**USH 41 EXPANSION -  
BROWN COUNTY:  
ROAD SAFETY AUDIT**

November 2007

H-U0011.02

***Lombardi Southbound Off-ramp***

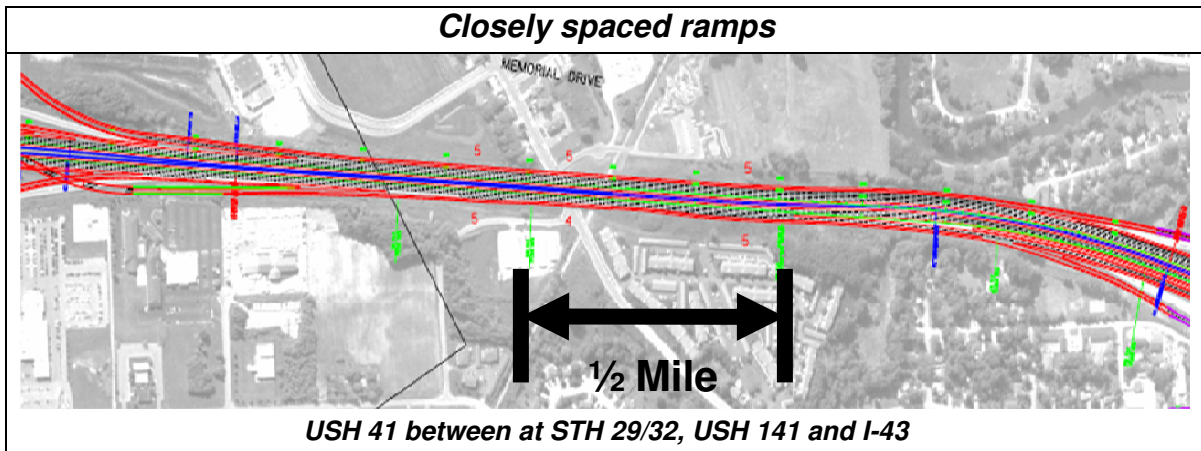
A vertical curve reduces intersection conspicuity on the above off-ramp. This is likely a cause of the trend of rear-end collisions occurring on this off ramp. This vertical curve will also likely obstruct the view of the proposed roundabout.

4. *Re-grade Ramps:* Reducing vertical and horizontal grades will improve sight distance on on-ramps and off-ramps, and will increase decision sight distance. This is particularly an issue at the Lombardi Avenue (CTH VK) interchange. The 22 rear end collisions which occurred on the southbound off-ramp at Lombardi may be prevented by leveling the vertical curve.
5. *Lighting* should also be considered on the 90 degree curve on the northbound off ramp to CTH F.

**STH 29 & Old Dousman Street**

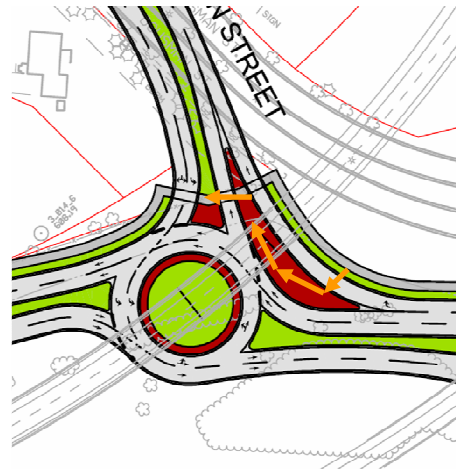
**Safety Issue 2(a) Description:** High speed right-turn bypass lanes are planned at several of the proposed roundabouts on the corridor. These are primarily being utilized on the on- and off-ramps to maximize the operational performance of the roundabouts.

On several of the bypass lanes which are being planned for freeway on-ramps, crosswalks are proposed to be located near the end of these high speed right-turn lanes. The location of these

crosswalks may result in conflicts with pedestrians due to the limited sight distance visibility of the crosswalk and the increased speeds. In addition drivers will be accelerating as they approach these crosswalks. For this reason, several WisDOT regions are proactively removing these types of high speed right turn lanes at existing traditional intersections.

NCHRP 572<sup>2</sup> states roundabout exits have a higher percentage of vehicles that do not yield to pedestrians than roundabout entries, suggesting that the design of the exit should be carefully considered to ensure vehicle speeds are reasonable and that good sight lines exist between drivers and pedestrians.

1. *Offset Pedestrian Crossings:* Offsetting the pedestrian crosswalk will improve the visibility of the crosswalk and alert drivers of pedestrians before accelerating speeds on the on-ramp (*right*). If offset pedestrian crossings are utilized, fencing or other similar barriers are suggested as a means to channelize pedestrians to the designated crossing area.

2. *Removal of Bypass Lanes:* High-speed rights are being eliminated throughout intersections in Wisconsin because of increased pedestrian risks. The bypass lanes may be removed as a way to prevent pedestrian conflicts.

**USH 41 NB Off-Ramp  
at Onieda/Waube**

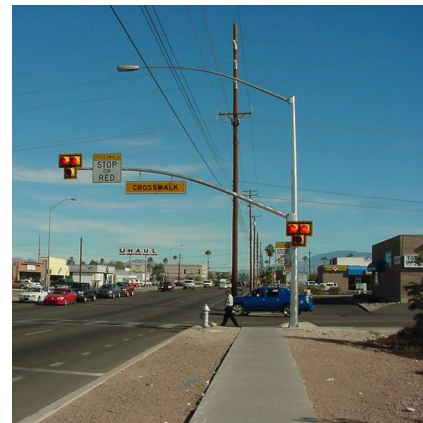
**Safety Issue 2(b) Description:** During site visits, light pedestrian volumes were observed, associated mainly with nearby restaurants, shopping centers, and transit bus stops. Pedestrians who cross without pedestrian signal heads may unintentionally enter the crosswalk with insufficient time to clear it before conflicting traffic. The risk of a potentially high-severity pedestrian or bicycle collision is increased by the absence of signal heads that indicated to pedestrians when then can safely cross the three-lane approach. This risk is increased when visually impaired pedestrians. NCHRP Report 572

states that more lanes resulted in a higher number of vehicles not yielding to crossing/waiting pedestrians (43% on two-lane sites versus 17% on one-lane sites)<sup>3</sup>. The increase of lanes makes it more difficult for pedestrians to cross, mainly because of non-yielding drivers.

1. *Median Refuge:* A median refuge may be used to allow pedestrians to clear traffic in one lane and then the next two lanes. This will decrease crossing distance and pedestrian workload resulting in fewer conflicts.

2. *Active Pedestrian Traffic Control:* A HAWK (High-Intensity Activated crosswalk) signal may be used to control traffic and safely direct pedestrians across a three-lane crosswalk. The HAWK signal, developed by the City of Tucson Arizona, is dark until activated by a pedestrian and then it cycles through flashing yellow, steady yellow, steady red, and then flashing red. The traffic and pedestrian signal displays are shown below in FIGURE 2.1. NCHRP 562<sup>4</sup> states that drivers are more likely to stop for a device that displays a red indication, resulting in a driver's average compliance rate of 96 percent with the installation of a HAWK signal. Verse a driver's average compliance rate of 17 percent to 62 percent depending on speed limit (25 mph of 35 mph respectively), with the installation of high visibility signs and markings. HAWK signals improve pedestrian safety and improve drivers stopping behavior.

**Onieda/Waube SB Exit Ramp**

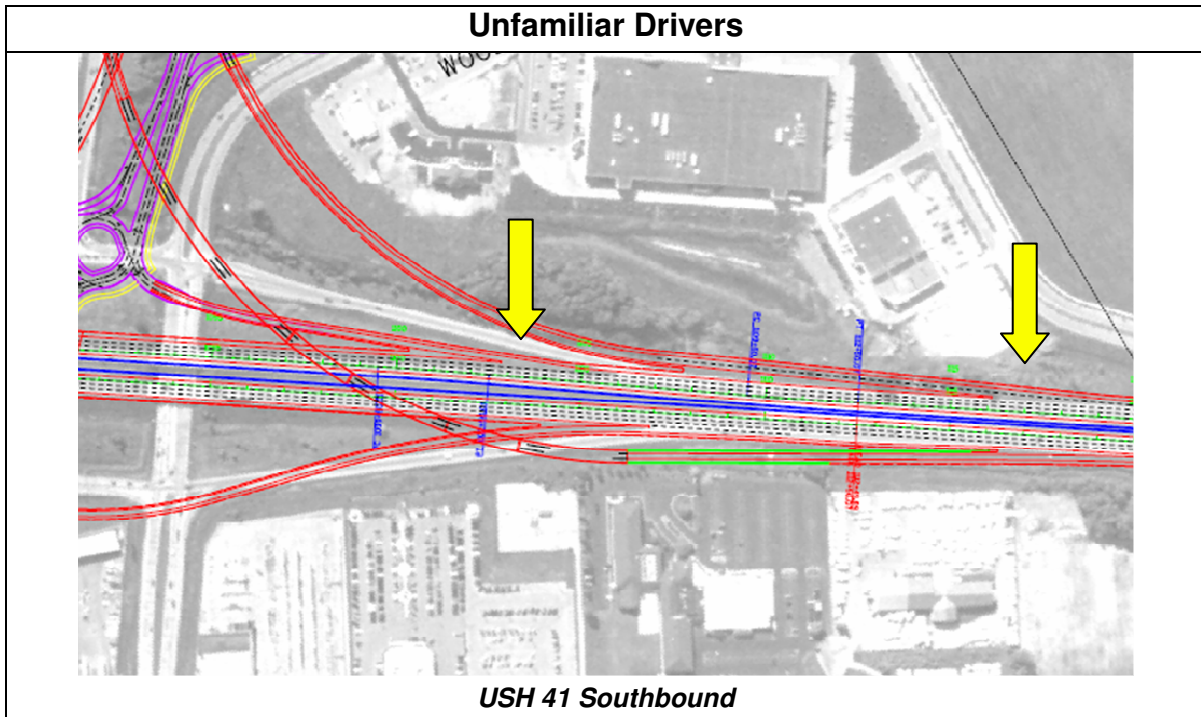
**Safety Issue 3(b) Description:** Southbound right-turn volume of 1150 vehicles per hour at CTH AAA (Oneida Street/Waube Lane) was not considered in roundabout analysis. As a result, this high volume right turning movement may be a major impact to the design. Furthermore, there may be issues with sight distance potentially resulting in angle crashes between southbound vehicles turning right and westbound vehicles exiting the roundabout.

1. *Add merge lane:* A parallel acceleration lane for right-turning traffic may be considered to allow right-turning drivers to accelerate for a longer distance before merging into the flow of traffic. At this location, a longer acceleration lane may require widening of the adjacent overpass structure.
2. *Revise analysis:* Include right-turn volume in analysis and redesign intersection if necessary.

### Safety Issue 6(a): Mid Valley Drive south of CTH G

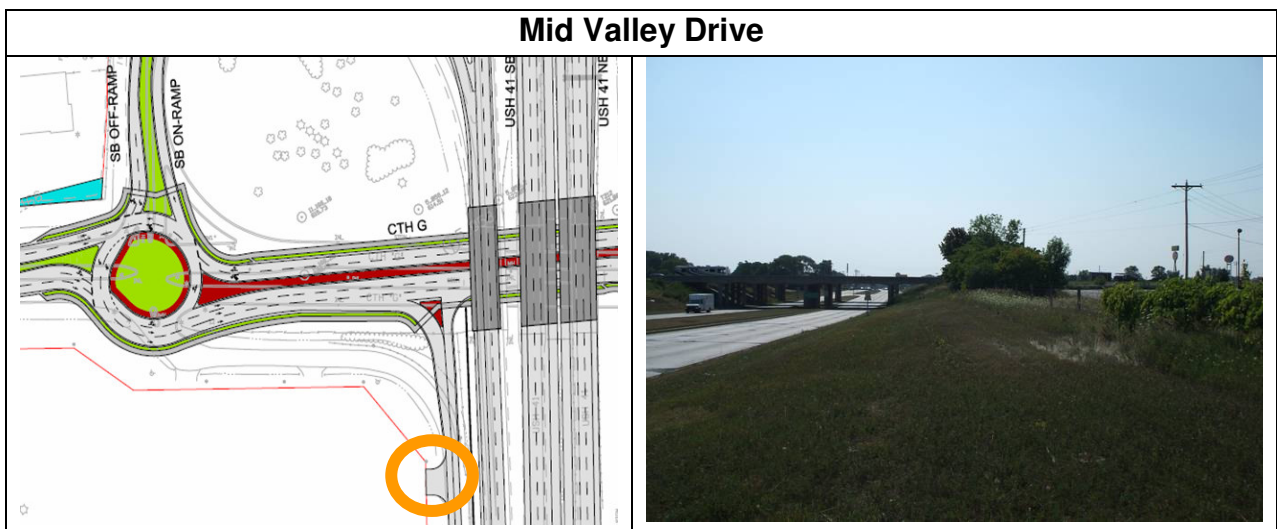
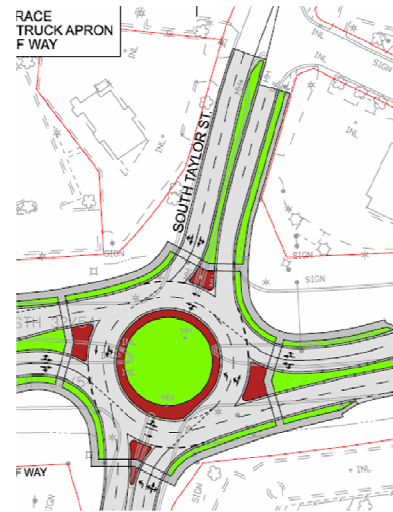
**Safety Issue 6(a) Description:** A new intersection between Mid Valley Road and CTH G is proposed. As a result the access to the gas station on Mid Valley Drive is being relocated. As a result, the proposed location may have some sight distance restrictions caused by the vertical alignment at the Mid Valley Road and CTH G intersection. Furthermore, drivers turning on to Mid Valley Road from CTH G may not be expecting vehicles to be entering the roadway due to the vertical sight distance restrictions.

1. *Relocate Driveway:* Relocate driveway further to the south. This will allow for a more gradual vertical curve on the Mid Valley Road approach CTH G.
2. *Review Vertical Alignment:* Review the vertical alignment of the road to determine the best placement for the driveway to allow trucks to reach allowable speeds.

**Safety Issue 6(b): Taylor north of STH 54 (Mason Street)**

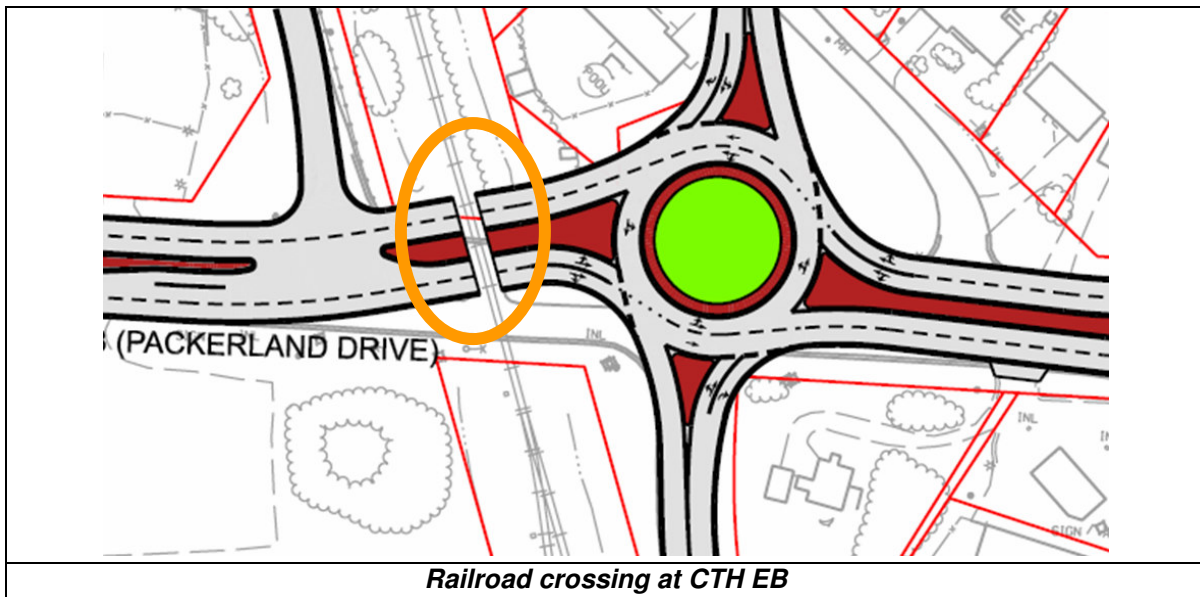
**Safety Issue 6(b) Description:** The median is extended just beyond the Circuit City driveway on Taylor Street north of Mason not allowing for left-turns. This may cause drivers to make U-turns around the median to turn into the driveway which may result in secondary rear-end collisions.

*Left-Turn Lanes at Major Driveways:* Shorten the length of the median to allow direct left-turns into the Circuit city driveway. This would result in the decrease of conflicts with vehicles making U-turns.
